SUBJECT: GEOLOGY/SEISMOLOGY REVIEW OF SER FOR UNION CARBIDE
SUBSIDIARY CO. LICENSE RENEWAL APPLICATION

In accordance with our agreement, we request the Geosciences Branch review of the geology and seismology sections of the Union Carbide reactor SER. The Docket No. is 50-54 and the PA No. is 1415.

Union Carbide Plot Plan
Figure *42e*
2.2

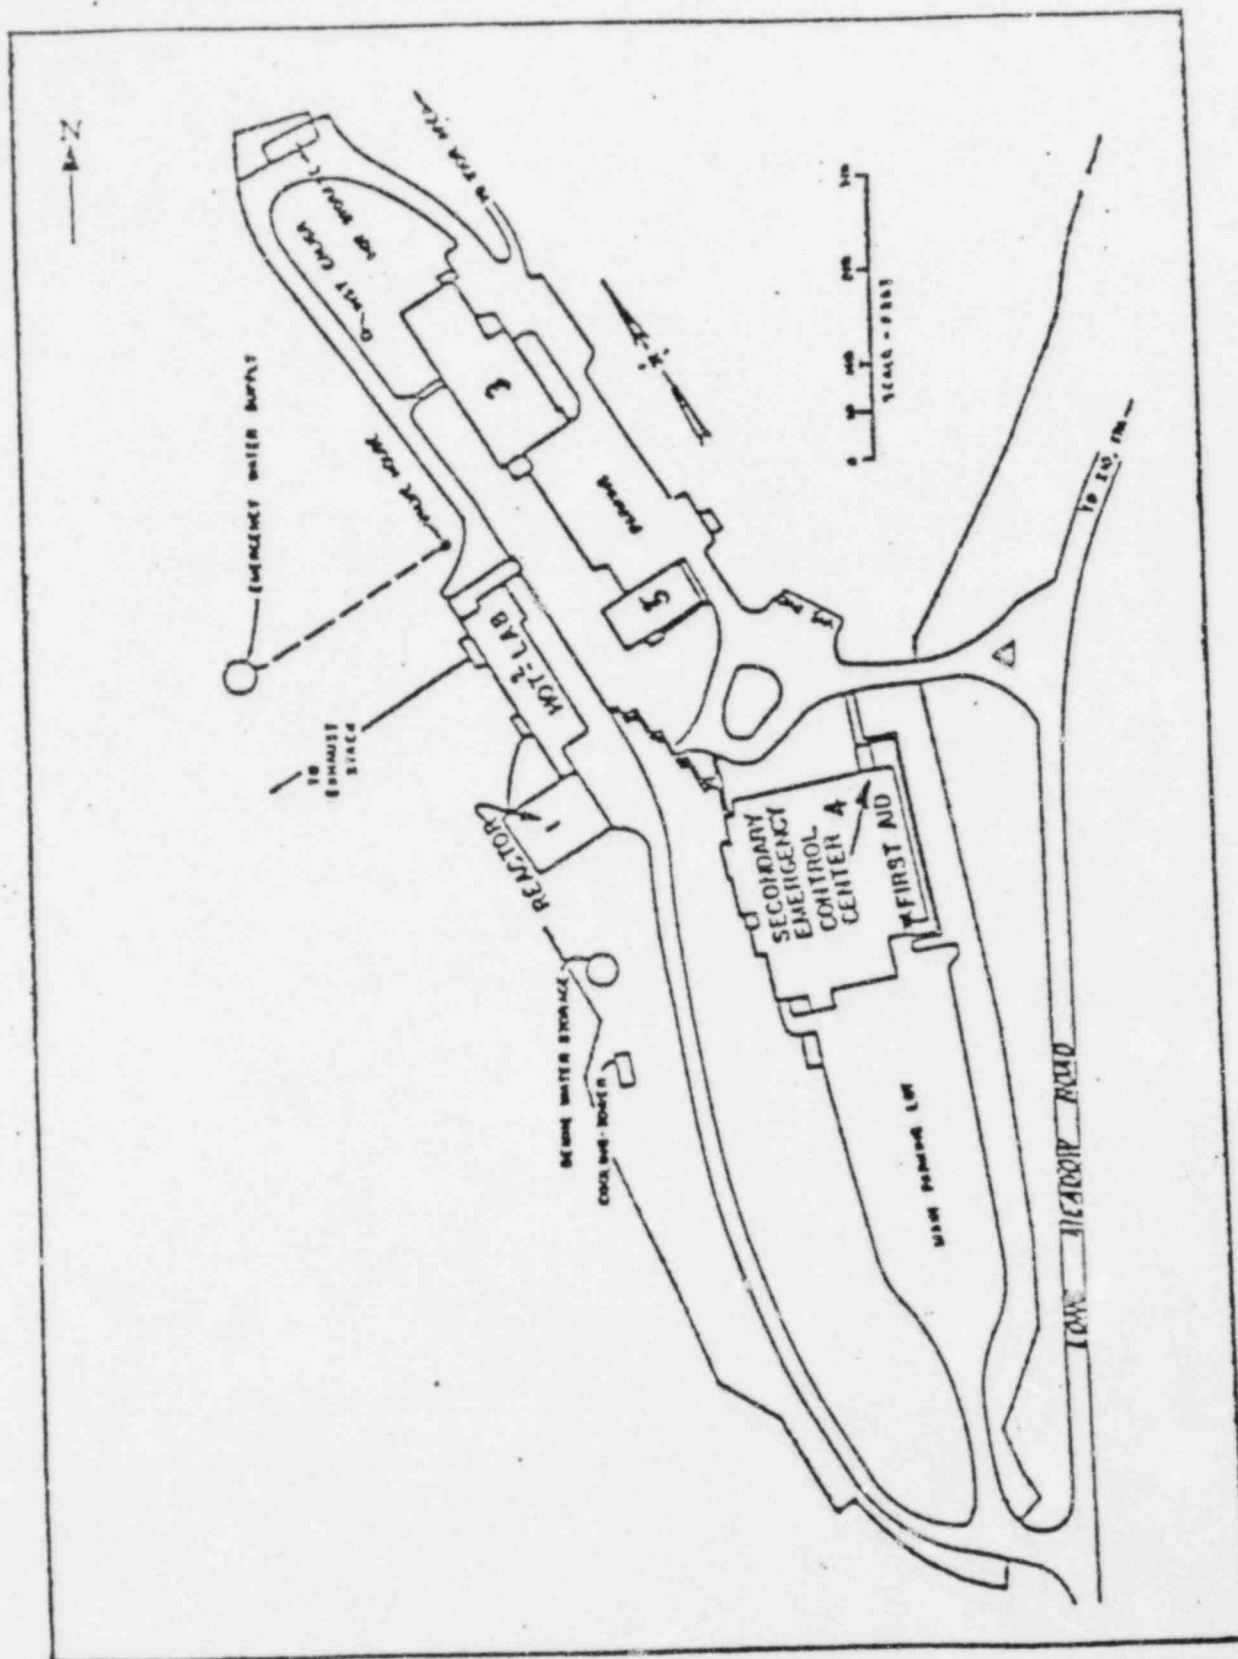
note to author —
unless you change the
words in the text, you
must use Figure 2,
Union Carbide Plot Plan,
if you use Figure 19,
you must use word Text.
you pick one!
OR use both!

↑ need better copy

Figure 2.3 Union Carbide Nuclear Company Research Center

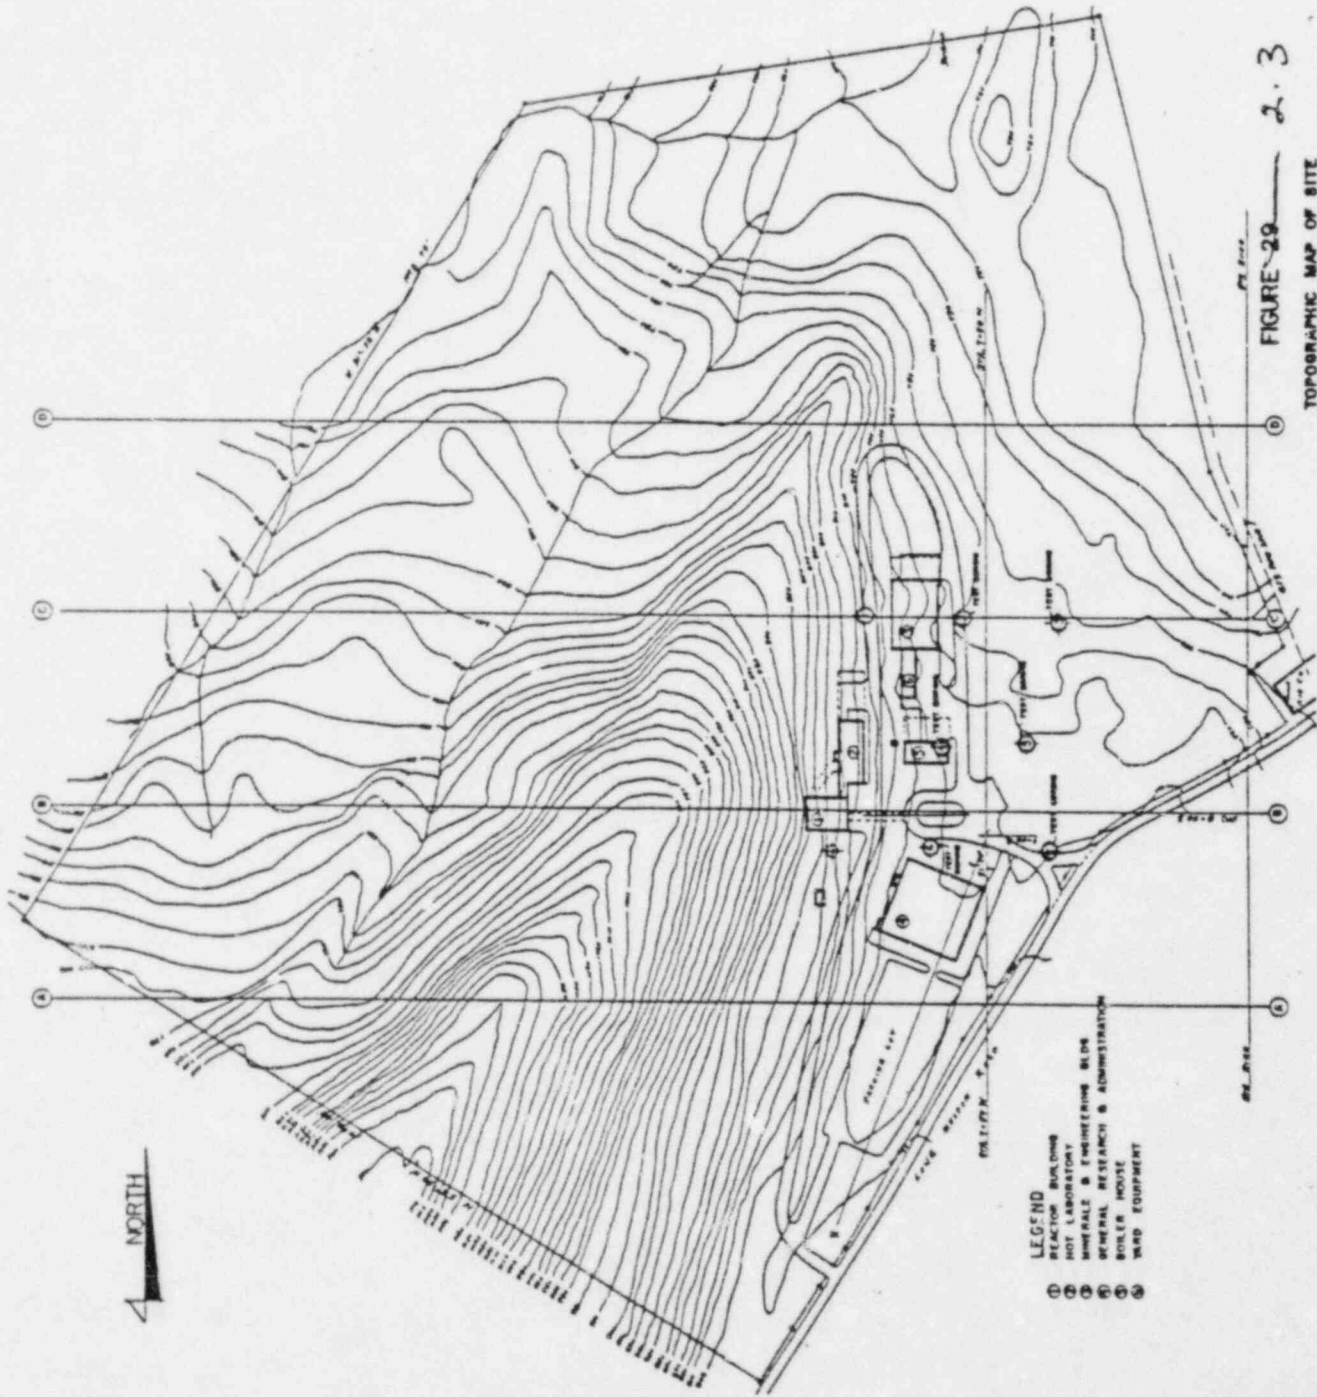
is this correct?
If not then UCL designation
is incorrect.

This figure should be used to clarify meaning in legend

Figure 2.5 Seismic risk map of the United States

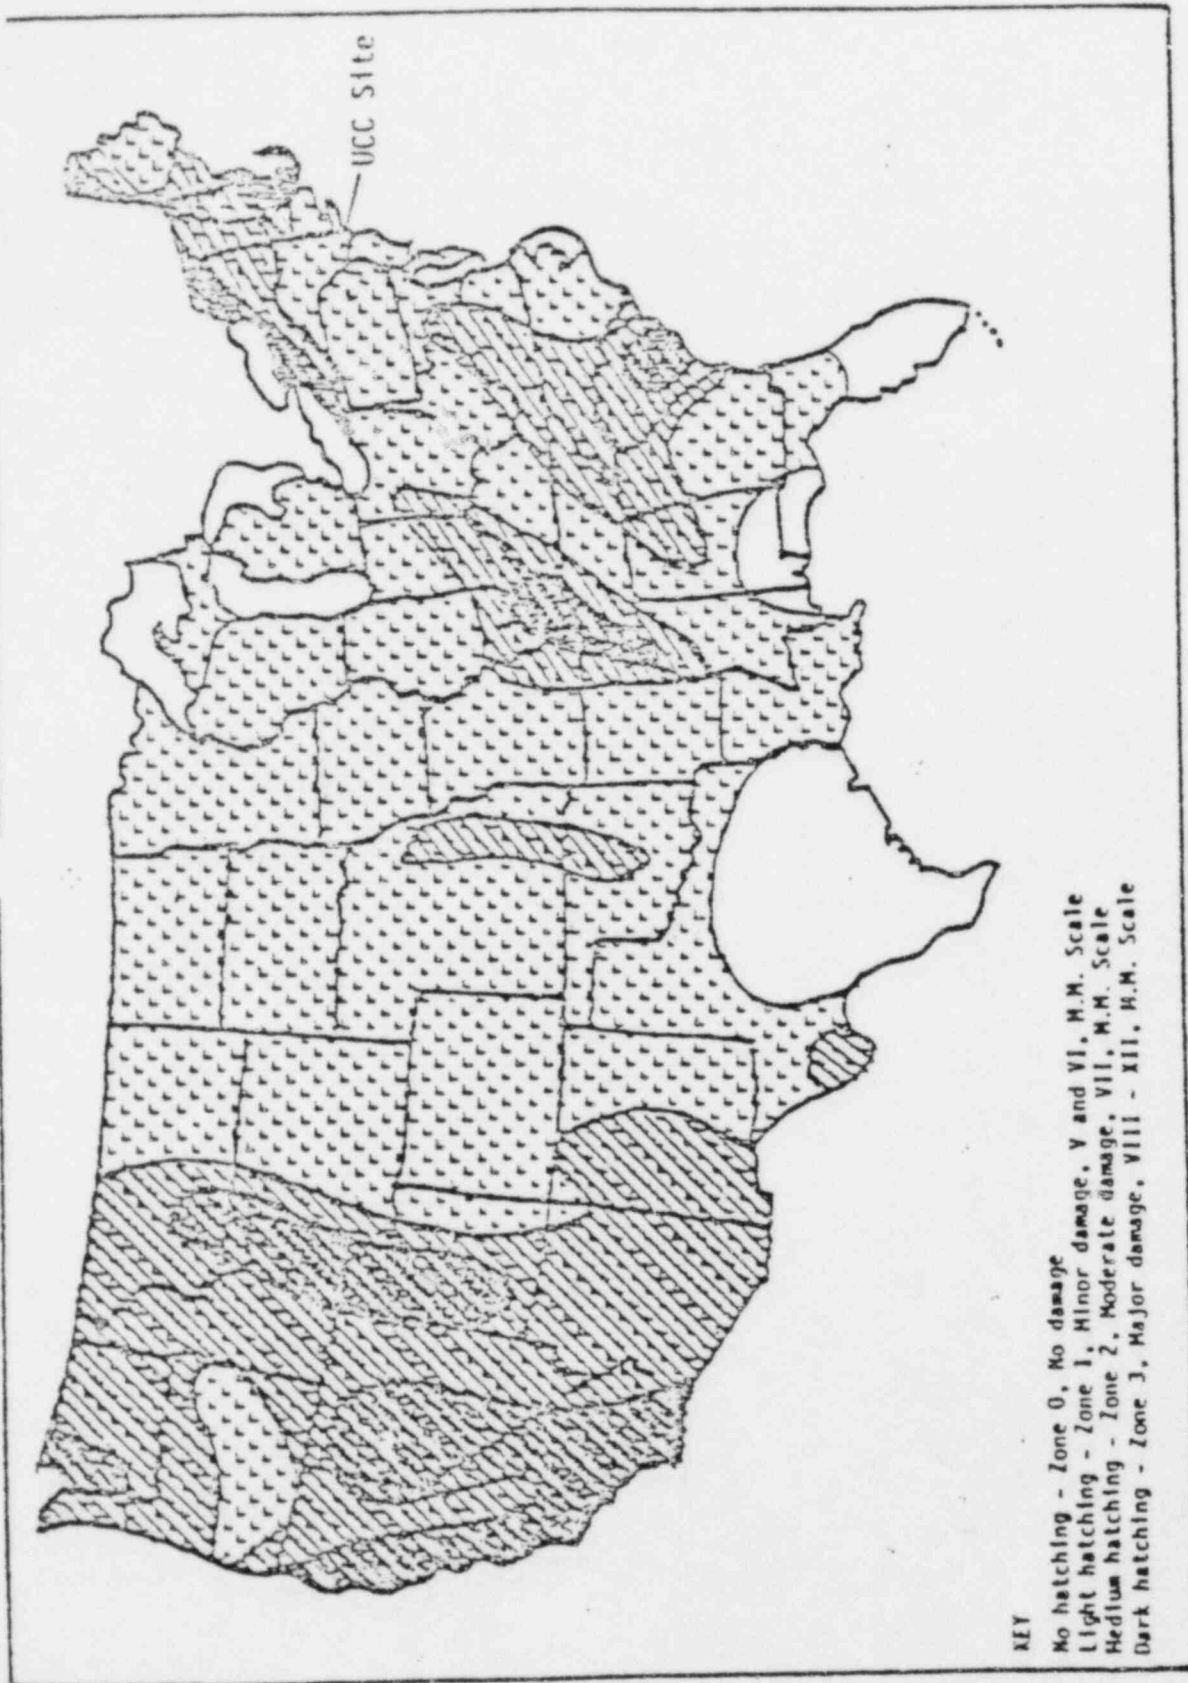
Can you
get further
copy?

Legend should
be redone
in Graphics

Figure 2.6 Earthquake epicenters within 60 mi. of the UCC site

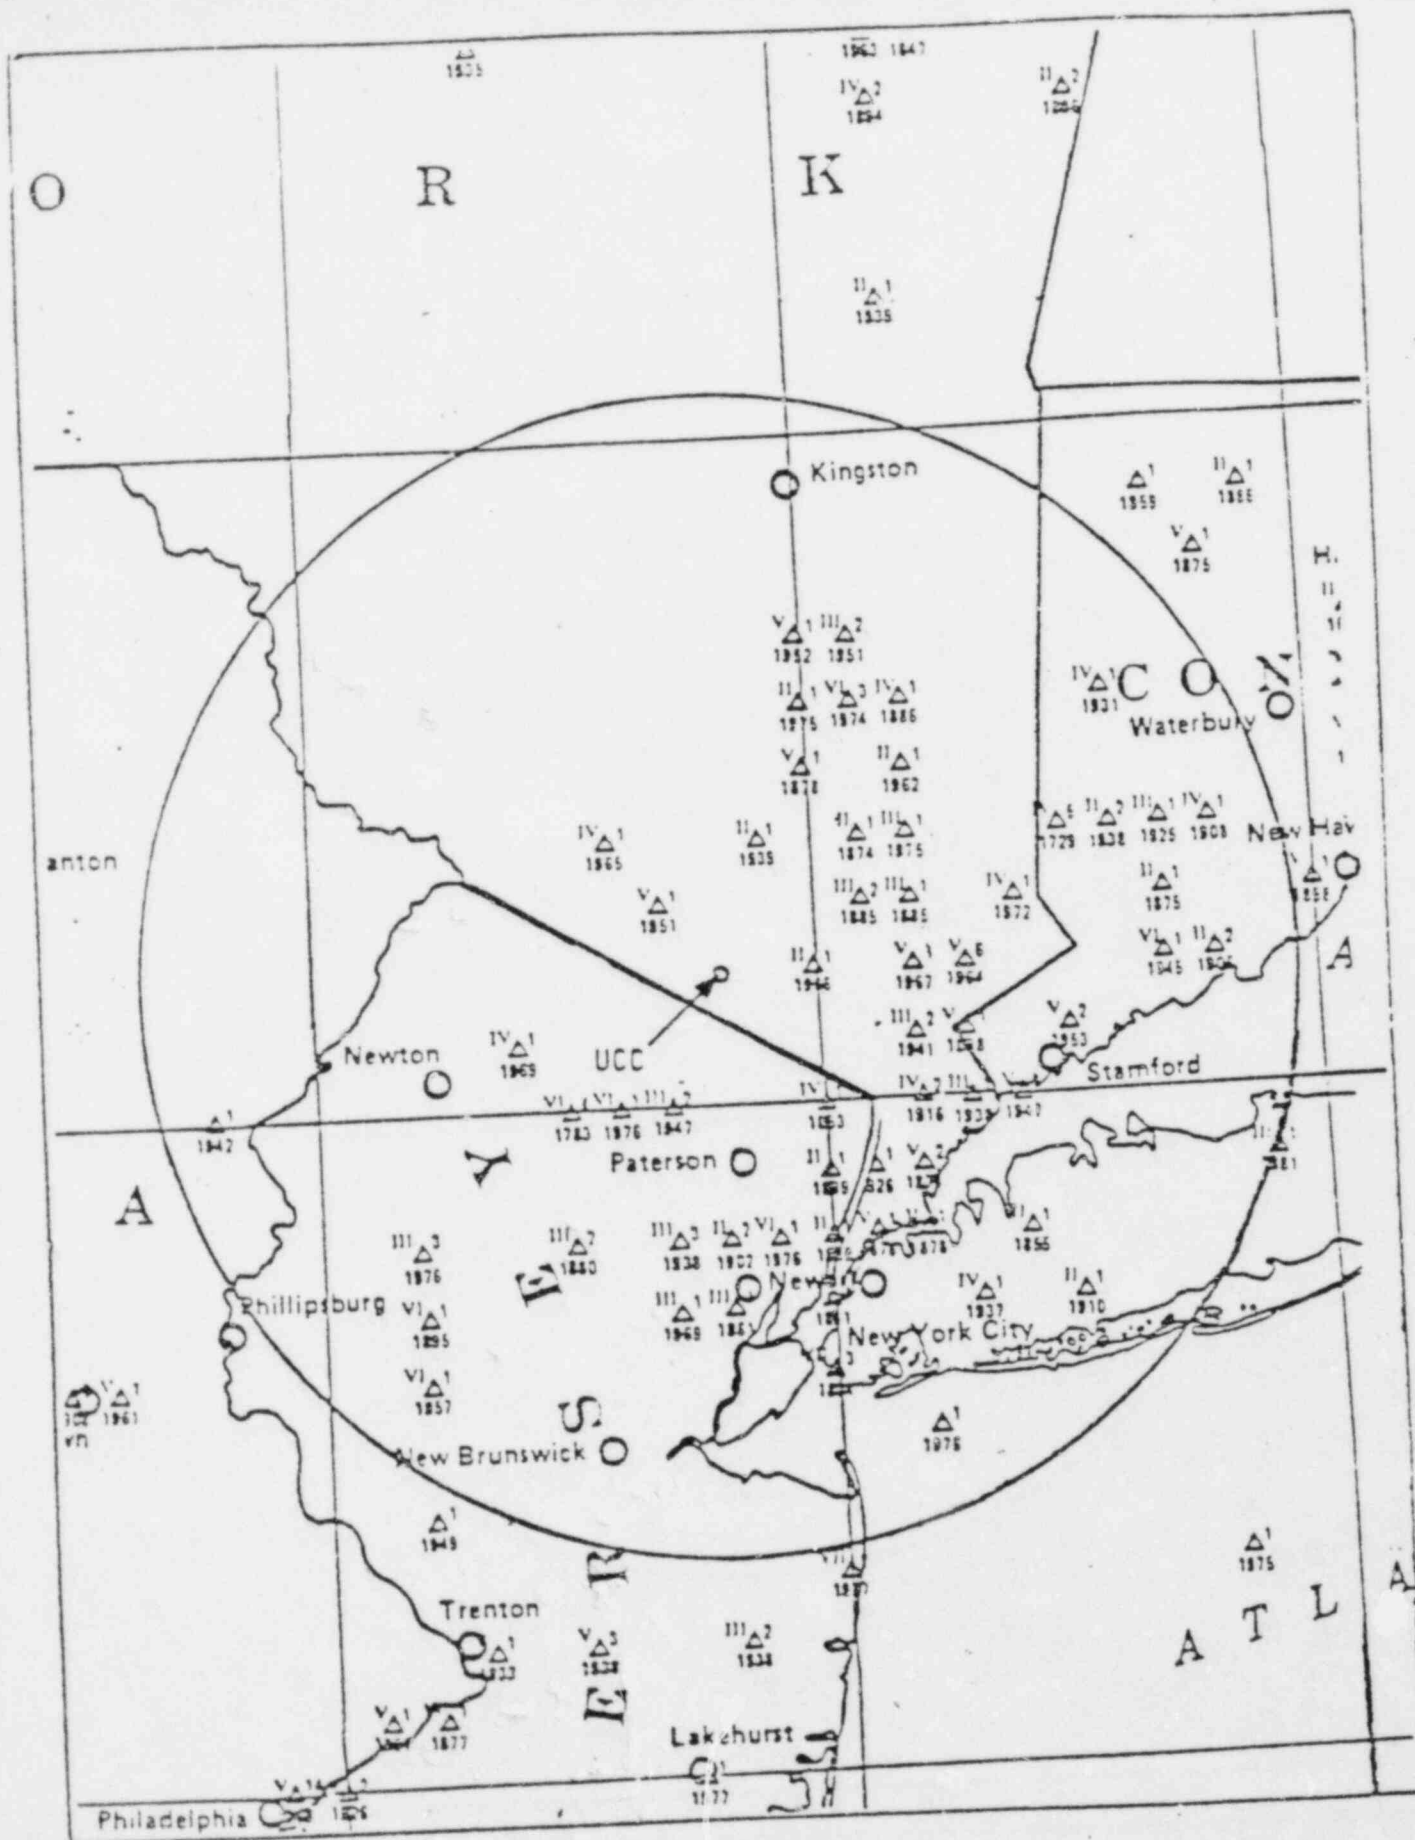
Set
(uncollected)
